# Wisconsin Department of Transportation

**Proposal #11: 5990-01-20/21, WISC 2015 121**  
**City of Janesville, Main Street**  
**St. Lawrence Avenue to Centerway**  
**Local Street**  
**Rock County**

This is Addendum No. 1, which provides for the following:

**ADDENDUM NO. 1**

Addendum No. 1  
 ID 5990-01-20/21  
 Revised Sheet 89  
 February 27, 2015

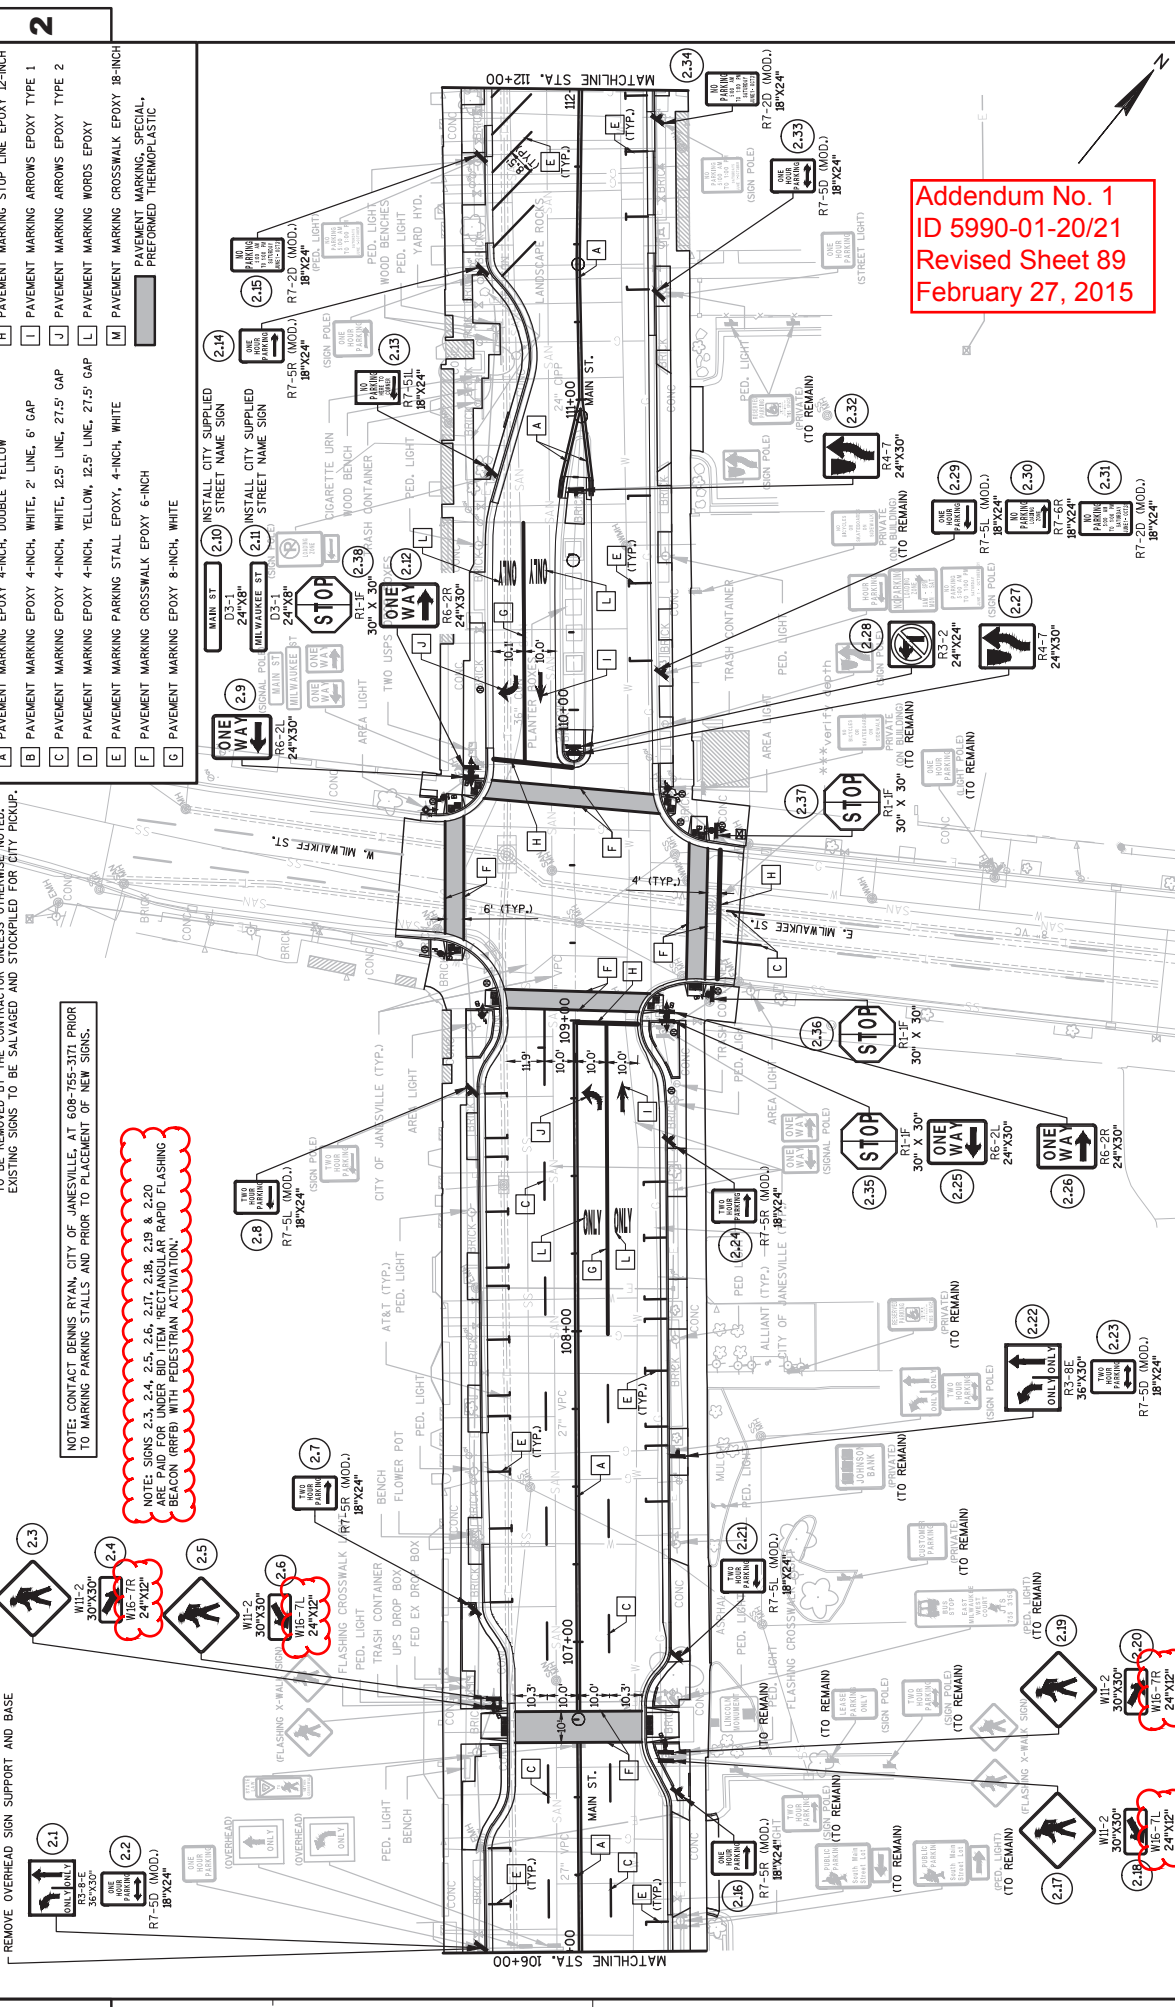
Revised Plan Sheets	
Plan Sheet	Plan Sheet Title (brief description of changes to sheet)
89	Signing and Pavement Markings (Revised notes for signs)
126	Miscellaneous Quantities (Updated Permanent Signing Table)
127	Miscellaneous Quantities (Updated Permanent Signing Table)

NOTE: SIGNS 2.3, 2.4, 2.5, 2.6, 2.7, 2.8, 2.19, & 2.20 ARE PAID FOR UNDER BID ITEM 'RECTANGULAR RAPID FLASHING BEACON (REF) WITH PEDESTRIAN ACTIVATION'.
